Rosamond High Early College Campus Cafeteria Building
SOUTHERN KERN UNIFIED SCHOOL DISTRICT
F&M Project No. 2990
Bid Clarification No.2; Page 1 of 2

BID CLARIFICATION NO. 2
June 30, 2023

SHEET 1 OF 6

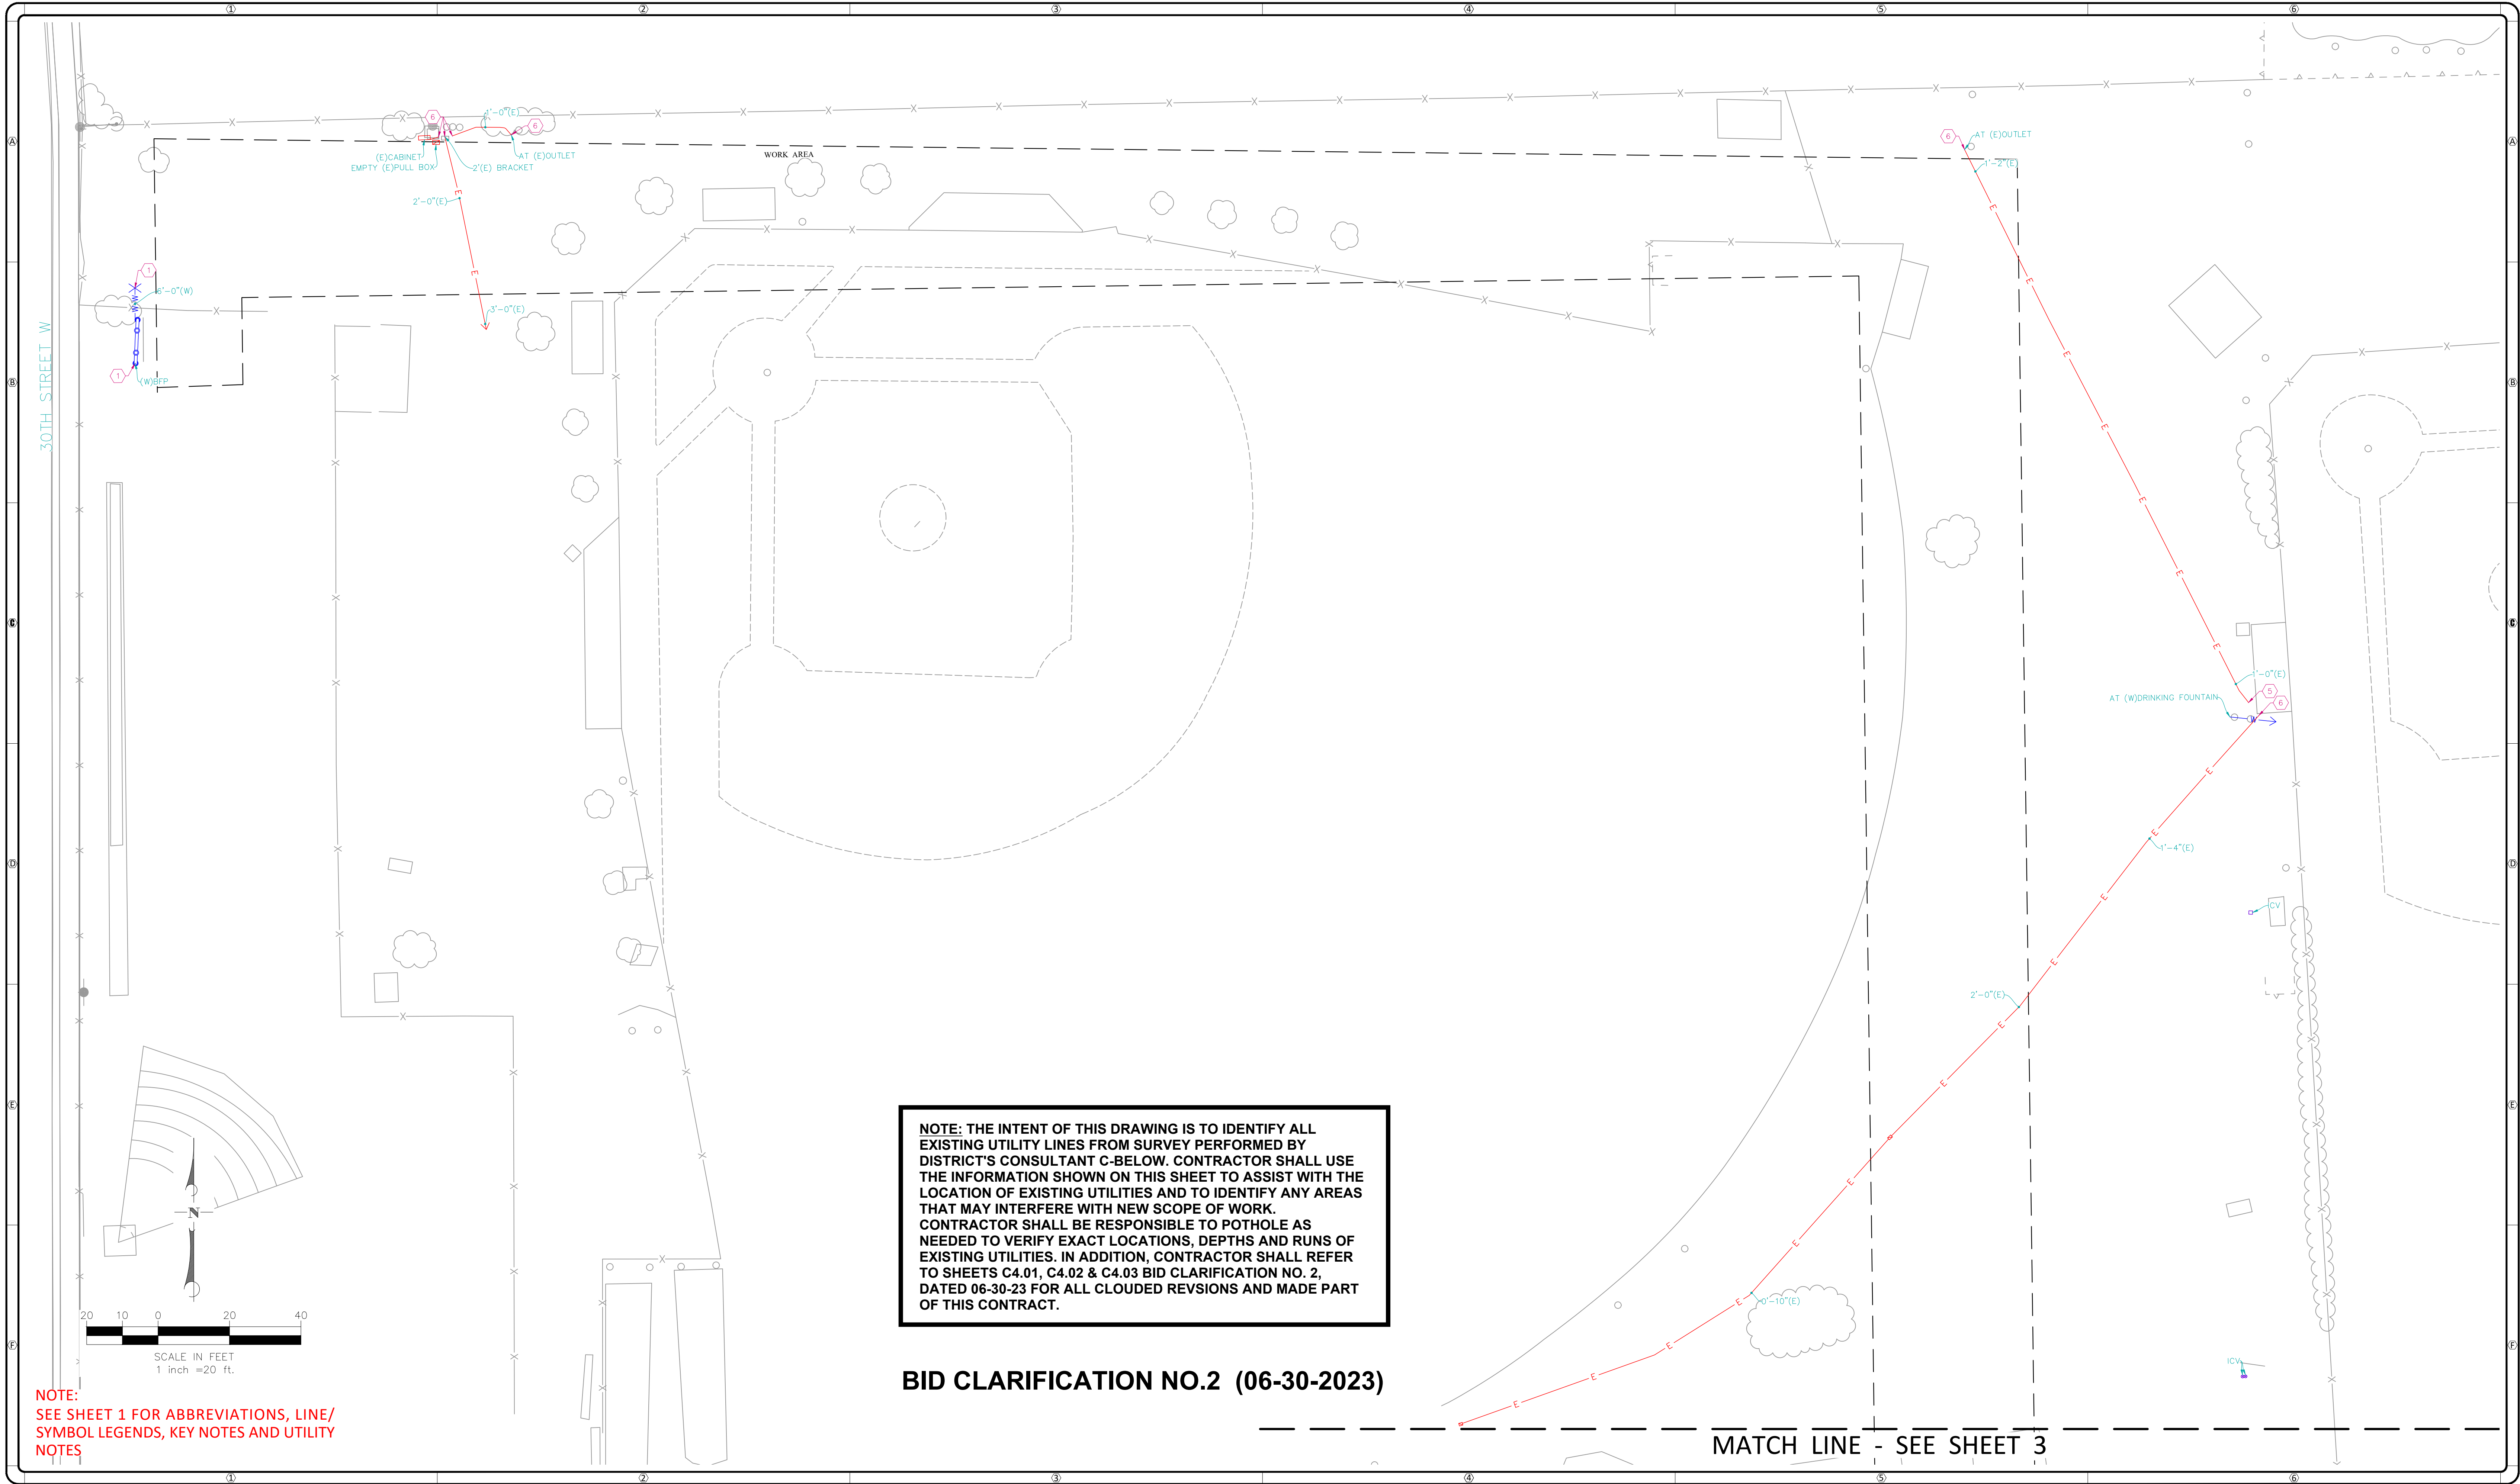
- a. Sht. 1 of 6 – Underground Utility Map (24”x30”)
- b. Sht. 2 of 6 – Partial Underground Utility Map (24”x30”)
- c. Sht. 3 of 6 – Partial Underground Utility Map (24”x30”)
- d. Sht. 4 of 6 – Partial Underground Utility Map (24”x30”)
- e. Sht. 5 of 6 – Partial Underground Utility Map (24”x30”)
- f. Sht. 3 of 6 – Partial Underground Utility Map (24”x30”)

NOTE: THE INTENT OF THIS DRAWING IS TO IDENTIFY ALL EXISTING UTILITY LINES FROM SURVEY PERFORMED BY DISTRICT'S CONSULTANT C-BELOW. CONTRACTOR SHALL USE THE INFORMATION SHOWN ON THIS SHEET TO ASSIST WITH THE LOCATION OF EXISTING UTILITIES AND TO IDENTIFY ANY AREAS THAT MAY INTERFERE WITH NEW SCOPE OF WORK. CONTRACTOR SHALL BE RESPONSIBLE TO POT HOLE AS NEEDED TO VERIFY EXACT LOCATIONS, DEPTHS AND RUNS OF EXISTING UTILITIES. IN ADDITION, CONTRACTOR SHALL REFER TO SHEETS C4.01, C4.02 & C4.03 BID CLARIFICATION NO. 2, DATED 06-30-23 FOR ALL CLOUDED REVISIONS AND MADE PART OF THIS CONTRACT.
